Deficiency found - Panel ‘C’ in Generator Building

ANAKTUVUK POWER PLANT

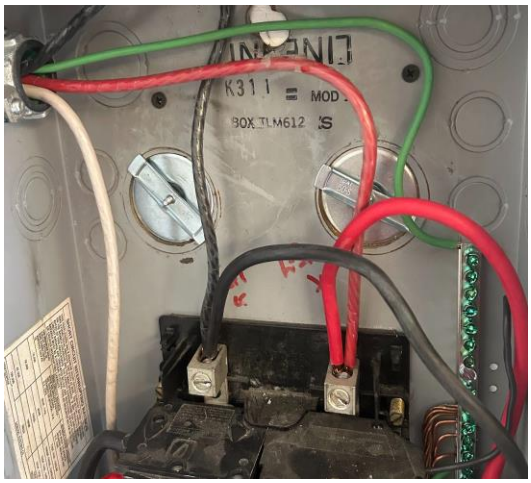
Currently the feeder for C1 (the wire that we added polaris connectors to) is landed on the main lugs with the incoming power from the inverter. It should have its own breaker.

3 ONE-LINE DIAGRAM - MACB - GENERATOR BUILDING (EXISTING)
NO SCALE

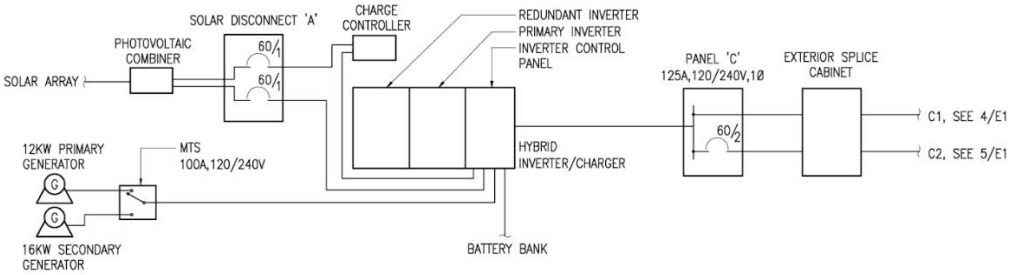
We recommend replacing Panel ‘C’ as part of any further work here. It is old and has many plugged holes. Possibly the feeders for C1 and C2 could be downsized between ‘C’ and the exterior splice cabinet (gutter), currently they are oversized for the 60A breakers being used.
